**MODIFICATION REQUEST:  
Site 4B, Sydney Olympic Park  
(MP06\_0273 MOD 1)**

Director-General's  
Environmental Assessment Report  
Section 75W of the  
*Environmental Planning and Assessment Act 1979*

August 2011

Figure 13: Eastern Elevation

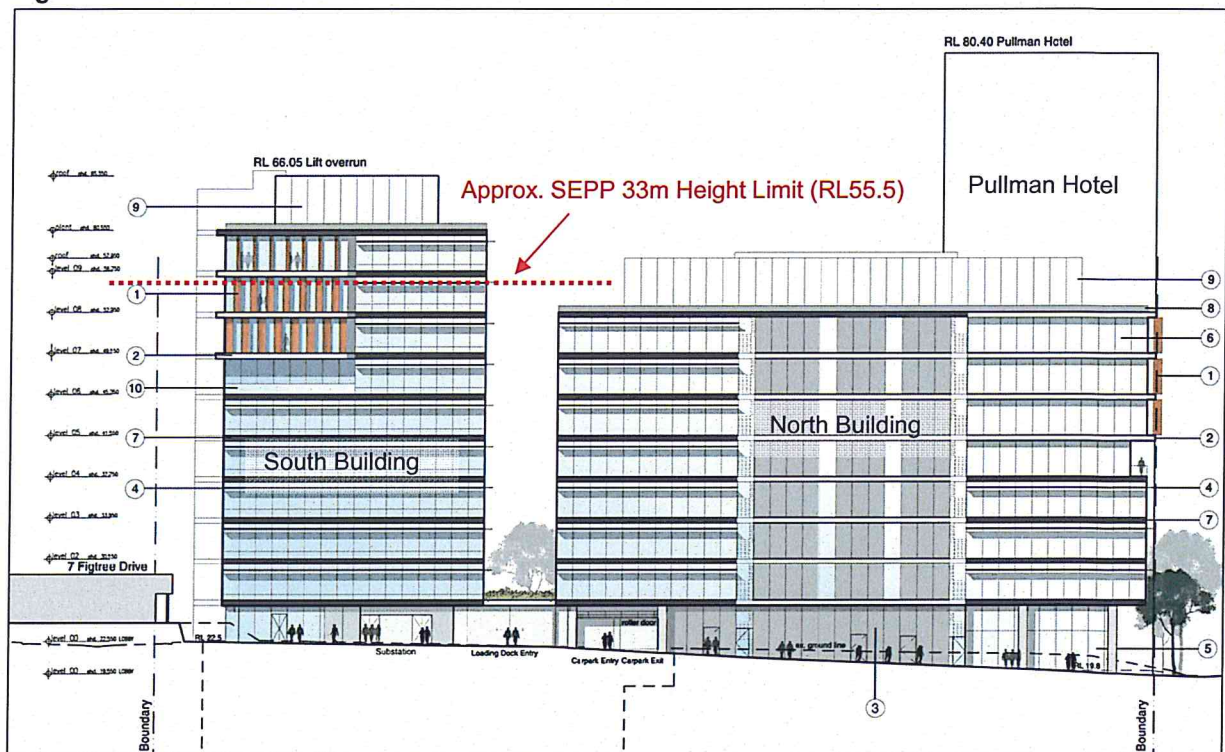
As detailed in Figures 10 and 12, the development site is subject to two maximum building height controls, with buildings fronting Olympic Boulevard restricted to a maximum height of 122m (20-32 Storeys Tower Zone), while development fronting Herb Elliot Avenue is restricted to a height of 33m (8 Storeys).

In this respect, the proposed modification results in a non-compliance with the maximum 33m building height for the subject site pursuant to clause 18 of Part 23 of Schedule 3 of the MD SEPP. Specifically, an eastern portion of the South Building, measuring approximately 24m in length, exceeds the maximum height by approximately 5m (see Figure 13) or by two storeys under the maximum 8 storey height control of SOP Master Plan 2030.

As outlined above, the Department considers that the proposed additional height will not significantly impact on adjacent land uses or on the future character of the Central Precinct. Further, SOPA has not raised an objection to the additional height of the Southern Building, noting that the reduced building footprint and superior design satisfactorily justify the departure. The Department considers that compliance with the development standard is unnecessary and that there are sufficient environmental planning grounds to justify the non-compliance. In this regard, it is recommended that the Director-General issues a certificate to this effect, pursuant to clause 21 of Part 23 in Schedule 3 of the MD SEPP.

Figure 14: Proposed – March @ 3:00pm

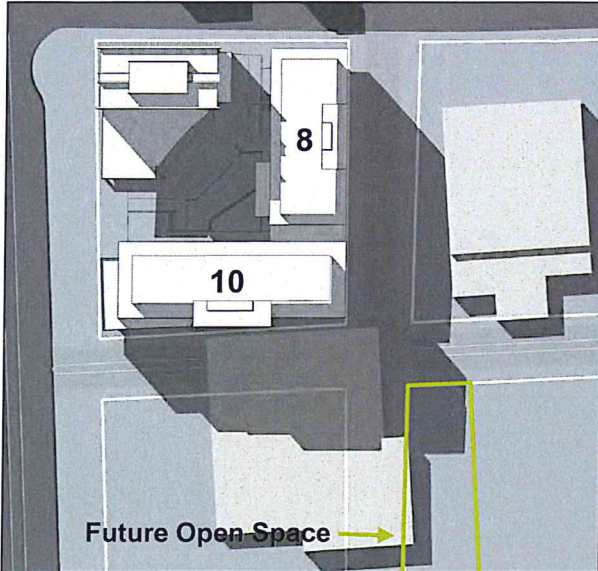
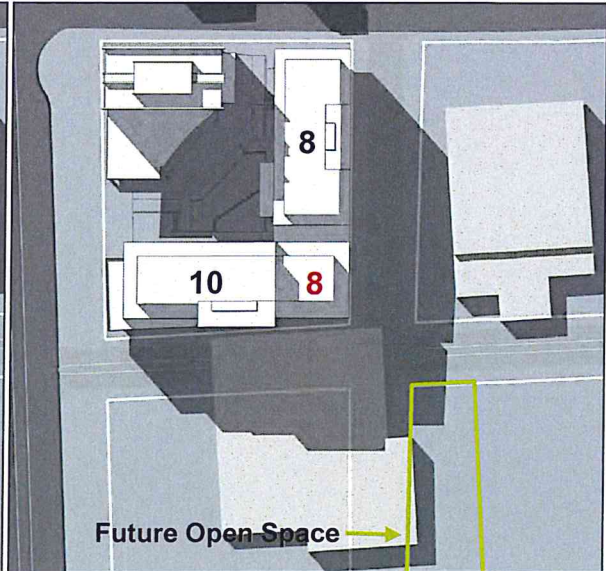
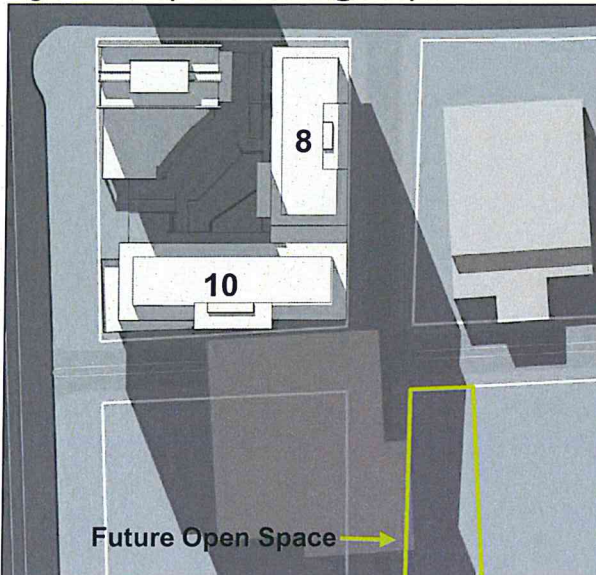
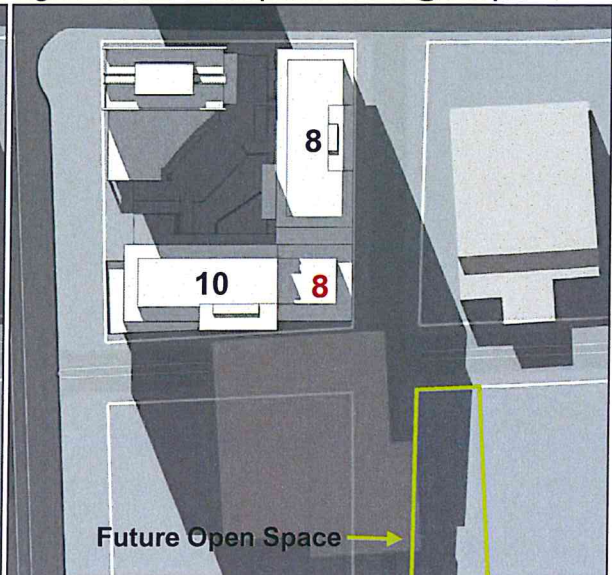
Having regard to the above, the proposed additional height of the southern building is not considered to have an impact on residential amenity, with the nearest residential development located approximately 100m south-east of the subject site on Figtree Drive. Furthermore, a shadow analysis undertaken by the Proponent (see Figures 14 – 17) demonstrates that any increase in afternoon shadows cast across the future public open space, located diagonally opposite, between a compliant 8 storey built form or the proposed 10 storey built form, would be negligible.

**Figure 22: Public Domain Interface/Loading Dock/Car Parking Access**

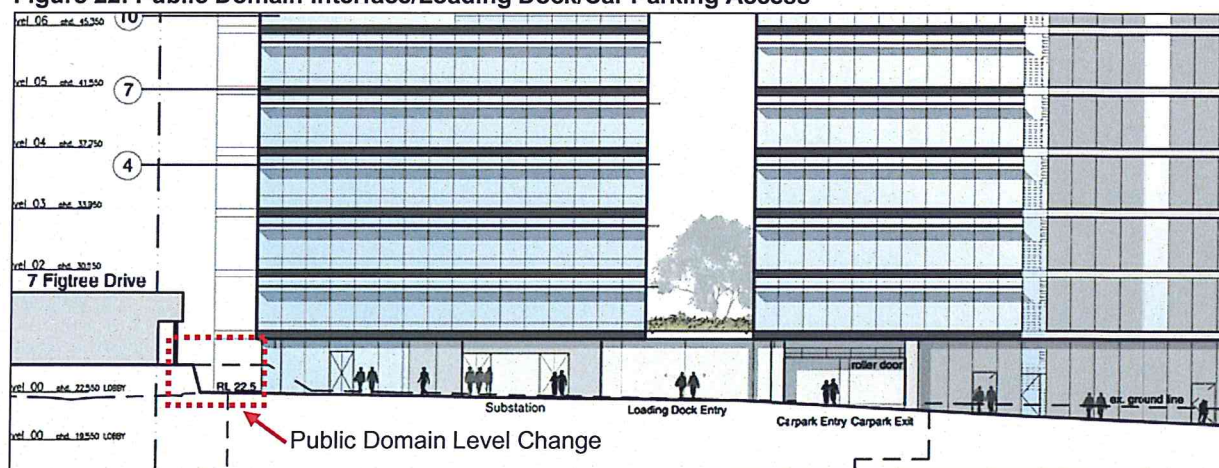
SOPA have also recommended that the Proponent provide for stairs, ramps and retaining walls to resolve issues surrounding the 400mm – 800mm change in levels at the interfaces between the southern and eastern elevations with the public domain/footpath and future East West Street (see Figure 22). To ensure that future road works and pedestrian access is not compromised, the Department considers the recommended works necessary. Accordingly, the Department recommends a condition requiring the public domain works to the footpath/new East West Street interface be designed and completed to the satisfaction of SOPA.

Concerns were raised by SOPA that the proposed roller shutter door treatment to the car park entrance was not going to be provided to the loading dock opening. Within the Proponent's PPR submission, it was advised that the loading dock would have the same treatment. SOPA also recommended that the loading dock entry be reduced in width and the driveway of the car park entry and loading dock be separated to provide for improved pedestrian amenity and safety. With regard to the roller shutter door treatment, the Department recommends an appropriate new condition be imposed to ensure that the finish is consistent.

The Department considers the proposed modifications to the public domain to be satisfactory, subject to recommended conditions, with suitable access and shelter provided to ensure that the public domain surrounding the proposed development is active and vibrant. It should also be noted that the Proponent has provided a new commitment to ensure that all future public domain interface works are undertaken in accordance with the standards outlined within SOPA's *Urban Design Elements Manual 2008*.
